City of Albany
Planning and Zoning Commission
MEMORANDUM

Subject: 423-427 Talbot

City of Albany
Planning and Zoning Commission
Staff Report

Subject: 423 and 427 Talbot Avenue. Continuation of Planning Application 08-037. **Parking Exception. Design Review.** Request for Design Review approval on an application to construct a new twelve-unit, three-story, multi-family building. A parking exception is also requested to allow a reduced number of parking spaces.

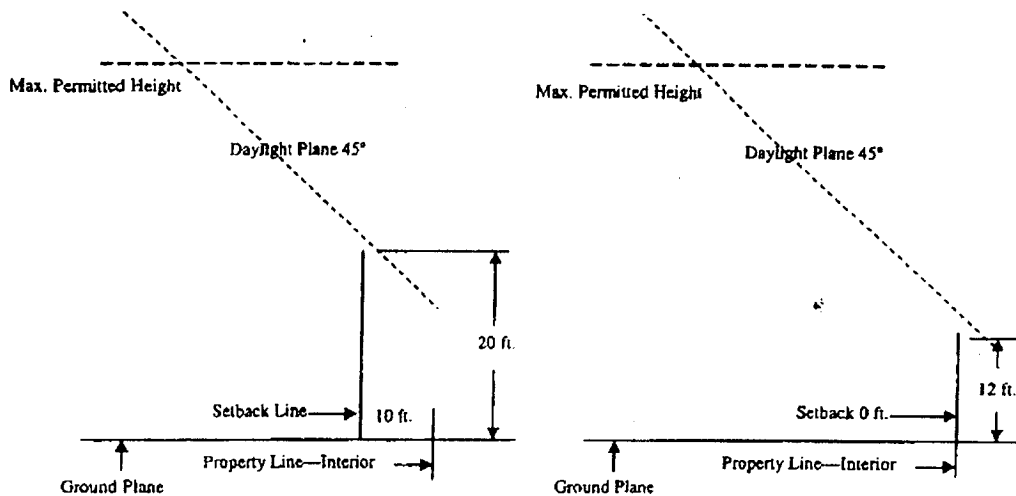
"I think that we need to reestablish the rear setback requirements where a commercial parcel abuts residential in the San Pablo Commercial (SPC) and Solano Commercial (SC) districts. These requirements existed with the previous zoning ordinance. I think that a case could be made that the setback requirements still exist with the current ordinance, but staff and the commission have concluded that the separate daylight plane calculations eliminate the need for any setback."

"A rear setback requirement in SPC and SC is critical to minimize the impact of large-scale commercial or mixed-use projects on adjoining residential districts. There needs to be a separation, a buffer, between these very large projects and neighboring residential parcels. I believe that most if not all neighboring cities impose setback requirements under these circumstances. It would be helpful if staff reviewed the requirements of other cities here and report their findings to the Commission. I think that the recent 934 San Pablo Ave. proposal, which would put decks and people at the rear property line, 12' - 15' above and overlooking the adjacent Adams St. parcels should be reviewed as an example of the problems associated with the lack of any setback. I think that Commissioner Moss's recent comments about building to the lot lines and the problems that this can create during construction and maintenance should also be considered. I think that the P&Z Commission should consider these points and carefully review the need for rear setbacks where commercial and residential districts meet."

"The basic purpose of the daylight plane requirement is to minimize the impact of a building's shadows on adjacent properties. Daylight plane requirements limit the maximum building height by imposing additional setbacks for portions of the building that exceed some threshold height. Section 20.24.070.A. describes the procedures for calculating daylight plane requirements in SC and SPC for interior property lines (rear and side) that abut a residential district. Two procedures are described. The first defines the daylight plane as a 45 deg plane drawn from a base point located 20 feet above the ground plane at the minimum required setback. This definition is completely consistent with the initial language of §20.24.070.A, which specifies the required "minimum setback" and then describes an "additional setback for any portion of any structure extending above twenty (20) feet in height..." The definition is also consistent with the basic definition of a daylight plane in the ZO, i.e., "'Daylight Plane' means a tilted plane that connects a vertical plane with a horizontal plane for the purpose of supplementing applicable setback" (§20.08.020)."

Figure 1 - Daylight Plane Comparison

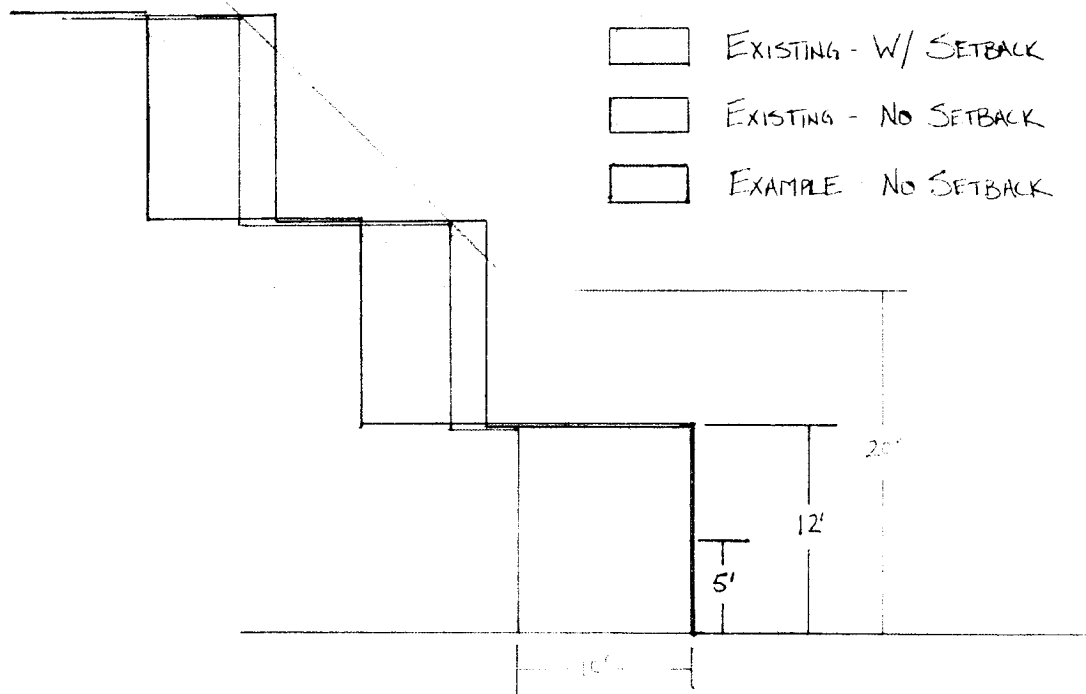
Another option would be to make the daylight plane for a development that has no setback requirement more stringent than the daylight plane with the setback requirement. One adjustment that could be made to result in a more equally sized building envelope would be to lower the height at which the 45 degree angle daylight plane begins in the second option.

By reducing the starting point from 12 feet to 5 feet, the resulting building envelopes would more closely match. The diagram below shows the basic effect of the change.
